APPENDIX G DFO AND TFO RESPONSES

EDTI-AESO-2019APR09-001

EPCOR Distribution & Transmission Inc.
AESO Questions for EDTI
EDTI-AESO-2019APR09-001
Page 3 of 6

**Figure EDTI-AESO-2019APR09-002-2
 72RG1 and 72RG7 Cable Proximity near Garneau**

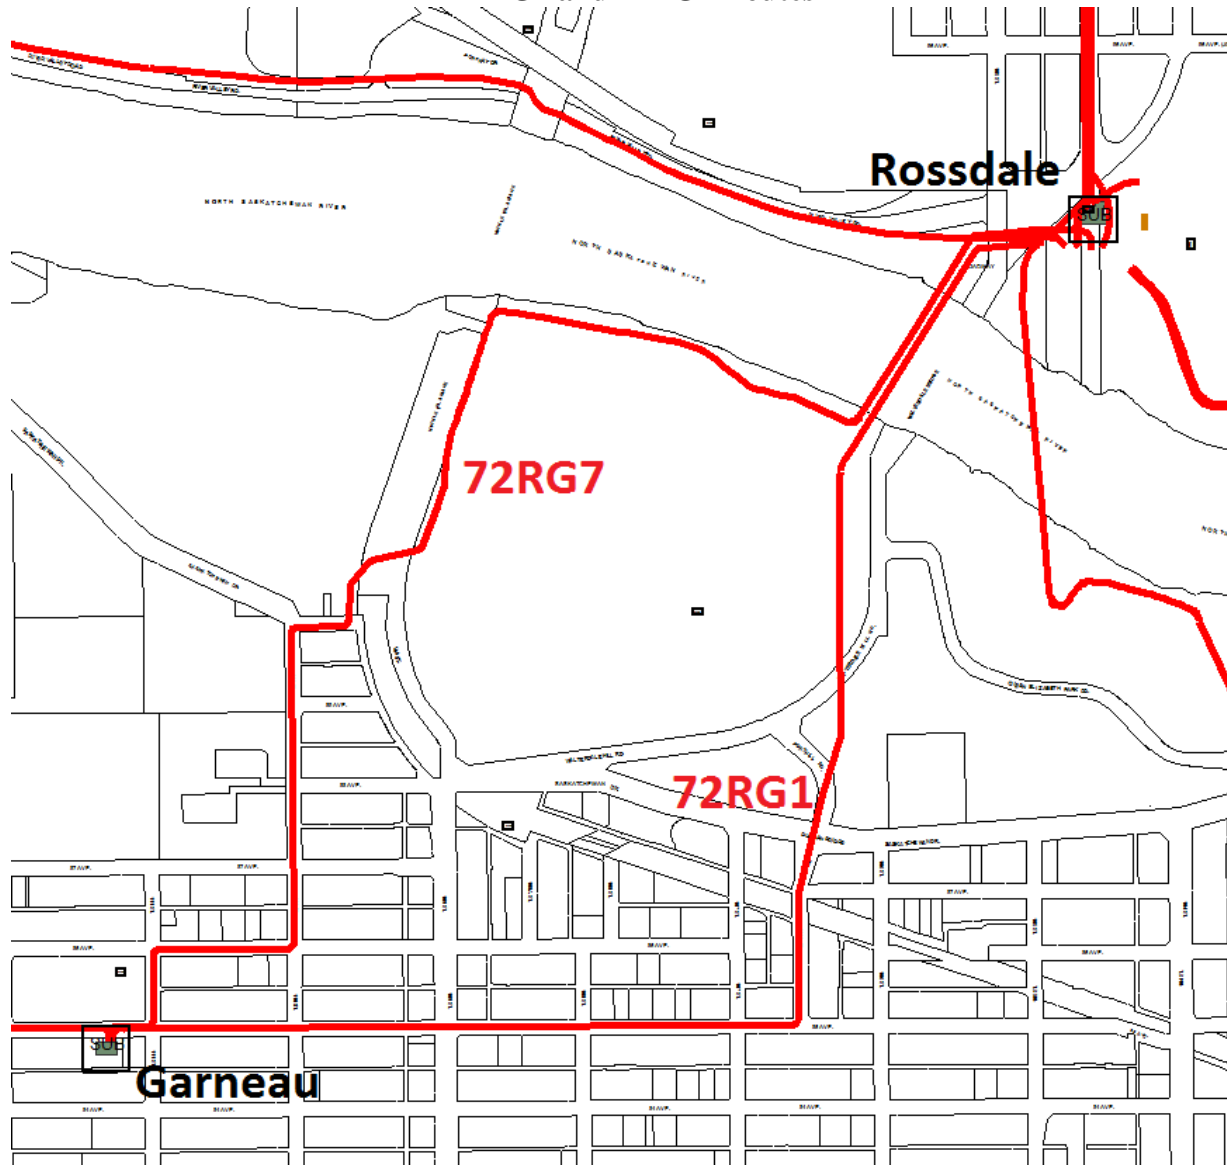
Are there any common elements (ie. sharing the same trench/duct or being exposed to common mode failures) between 72RG1 and 72RG7?

The two circuits connect to gas insulated switchgear (“GIS”) within the Garneau substation. From the switchgear lineup, each phase exits the north side of Garneau substation building through a 3” riser pipe. There is approximately 1 metre separating these pipes. The riser pipes come together (3 phases per circuit) in trifurcators (1 trifurcator per circuit) outside the building, and each circuit is then enclosed in its own 5” pipe. As shown in Figure EDTI-AESO-

2019APR09-002-2 below, the two circuits are separated by approximately 2 metres over a distance of 70 metres outside of Garneau, and transit through the same manhole (RG4), within which each cable is spliced.

As shown in Figure EDTI-AESO2019APR09-002-2, the circuits deviate from each other, about 55 metres northeast of the substation, with 72RG7 travelling north and 72RG1 travelling east. From this point, the separation between the two circuits remains greater than 100m until the North Saskatchewan River crossing, where they converge. The separation between the two circuits for the river crossing is approximately 13 metres. From the river crossing to the entry point at Rossdale substation yard there is approximately 16 metres of separation between the cables, and the terminations within the substation yard are about 48 metres apart.

Figure EDTI-AESO-2019APR09-011-1
2018 Summer Garneau 72 kV Load (Assumes No U of A Generation Available)
and Limiting Transmission Rating Following 72RG7 Contingency

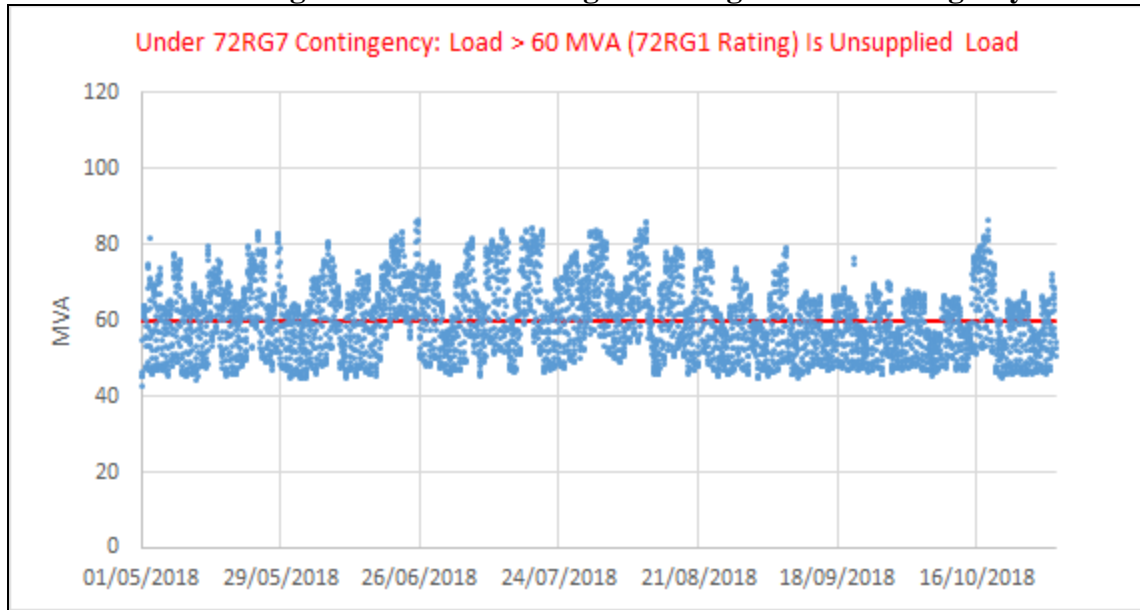
Provide relevant data on the amount of unsupplied load in the event of the above noted contingencies that could occur at different times of the year beyond just peak periods.

The figures below show the potential unsupplied load by hour if a 72RG7 contingency occurred in 2018 between May 1 and October 31. Of the contingencies considered, a 72RG7 contingency is likely to result in the largest amount of unsupplied load.
